Crystal River Nuclear Plant
Docket No. 50-302
Operating License No. DPR-72

Subject: Crystal River Unit 3 – Radiological Emergency Response Plan, Revision 30

CR3 Radiological Emergency Response Plan, Rev. 30
Description of Changes
Page 1 of 8

Revision 30 of the CR3 Radiological Emergency Response Plan (RERP) was initiated as a result of a review of the Plan and to address / correct inconsistencies between Table 6.1 and Section 6.3 of the Plan with information found in Emergency Preparedness Implementing Procedures EM-102, *Operation of the Technical Support Center (TSC)* and EM-104, *Operation of the Operational Support Center (OSC)*. These inconsistencies are documented and discussed in a "Quick Cause Evaluation Report" under NCR# 418801. The revisions to Table 6.1 and Section 6.3 do not change any staffing levels but are being made to more clearly show what the staffing levels are. A change is made in response to NCR# 398106-21, to correctly identify the position responsible for INPO notifications. Changes to Section 13.2.2 are also made to reflect current procedural instructions for post-accident sampling. Details of these changes are provided in the table below. The remaining

FIGURE 12.3
TSC/OSC FLOOR PLAN
SAMPLE

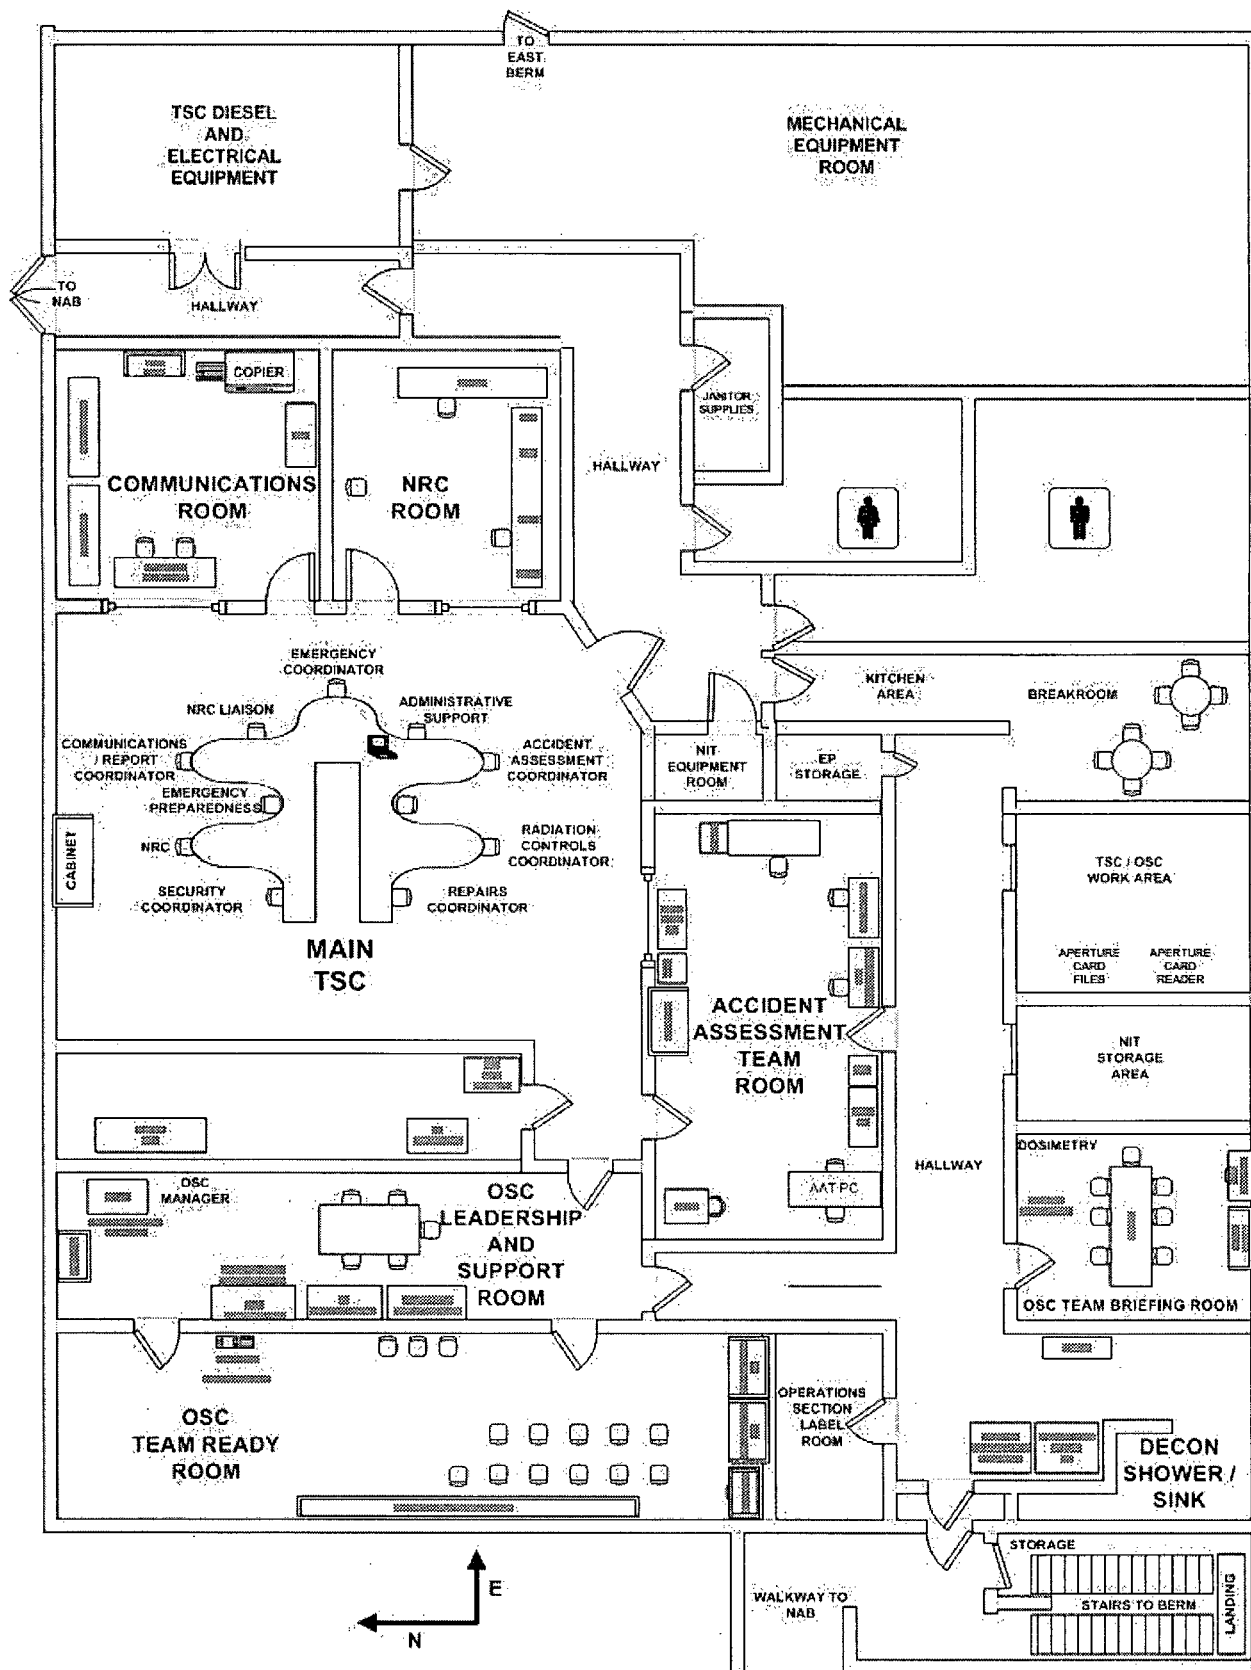
Page Numbers	Description of Changes and Comments/Rationale
	result of this change.
12-13	Figure 12.3. Replaced Figure to show the modified Work Area on the south side of the building which has had a partition wall added to it. The new space that this created is currently a storage area. The aperture card files and reader continue to be located within the Work Area. There is no decrease in effectiveness as a result of this change.
13-4	<p>Section 13.2.2; 7th, 8th and 9th paragraphs of section. Revised the 7th and 9th paragraphs to better reflect the current instructions as found in Emergency Plan Implementing Procedures CH-631, <i>Post-Accident Sampling and Analysis of Reactor Building Vent, and Reactor Building Atmosphere</i>, and CH-632, <i>Post-Accident Sampling and Analysis of Reactor Coolant, Decay Heat, and Reactor Building Sump</i>. The 8th paragraph is deleted in its entirety.</p> <p>As currently written, CH-631 provides guidance for collecting gas grab samples in the grab sampler WSSB-2 from Auxiliary Building (AB) vent, Reactor Building (RB) vent, and RB atmosphere; and particulate and iodine grab samples from RB and AB vents. Analyses are now performed off-site. Consequently, core damage correlations based on RCS samples would be performed using the off-site data. On-site core damage correlations continue to be available through containment high radiation monitoring, estimate of the time the core is uncovered, and RCS pressure/temperature relationship per EM-225.</p> <p>As currently written, CH-632 provides guidance for collecting gas grab samples in the grab sampler CASB-5 for Reactor Coolant System (RCS), Decay Heat (DH) , or RB Sump. Analyses are now performed off-site. Boron continues to be performed on-site by the boronometer for RCS, DH, and RB Sump.</p> <p>These changes are primarily as a result of the selected removal and partial abandonment of Post-Accident Sampling System (PASS) components and functions which were performed under Engineering Change (EC) #49486. A 10 CFR 50.54(q) evaluation for the EC was conducted under REG AR# 318622 with a determination that there was no decrease in effectiveness. That determination is applied to this change to the RERP as well.</p> <p>There is no decrease in effectiveness as a result of these changes.</p>
